HITACHI MICROCOMPUTER TECHNICAL UPDATE

DATE	23 August 2000	No.	TN-SH7-247A/E
THEME	SH-4 Handling of Reserved Pin and CA pin		
CLASSIFICATION	☐ Spec change ☐ Limitation on Use ■ Supplement of Documents		
PRODUCTNAME	HD6417750, HD6417750S, HD6417751	Lot No.etc.	All
REFERENCE DOCUMENTS	SH7750 series Hardware Manual SH7751 Hardware Manual	Rev. 1 - 4	EffectiveDate Eternity From

DATE	4 September 2000	No.	TN-SH7-249A/E
THEME	SH7751 AC characteristics of CKIO		
CLASSIFICATION	☐ Spec change ☐ Limitation on Use ■ Supplement of Documents		
PRODUCTNAME	HD6417751	Lot No.etc.	All
REFERENCE DOCUMENTS	SH7751 Hardware Manual	Rev. 1	EffectiveDate Eternity From

Figure 1. CKIO output Timing

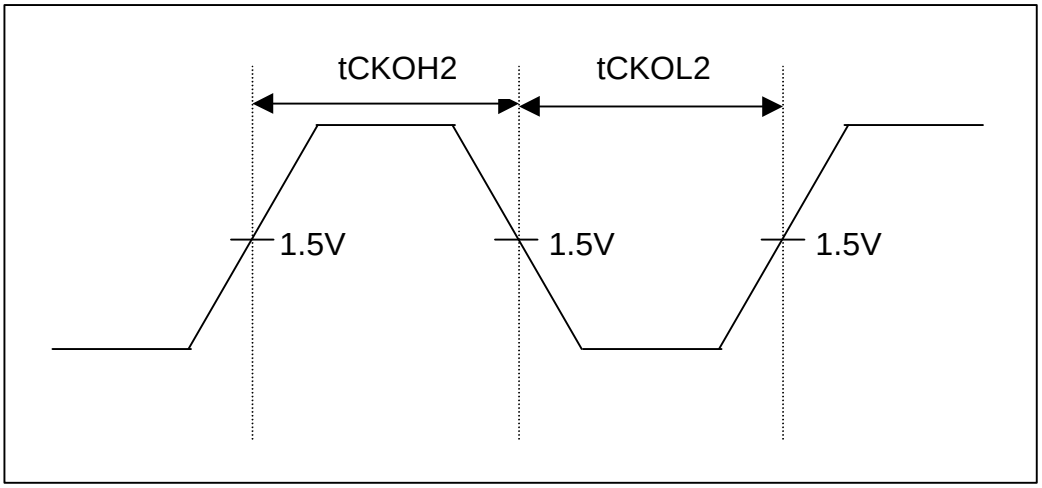
Two new AC parameters are added to SH7751 AC characteristics.

One is CKIO clock output high-level pulse width 2 (tCKOH2) and the other is CKIO clock output low-level pulse width 2 (tCKOL2) .

Product Name	Package	tCKOL2		tCKOH2		Unit
		Min.	Max.	Min.	Max.	
HD6417751	QFP	3	-	3	-	ns
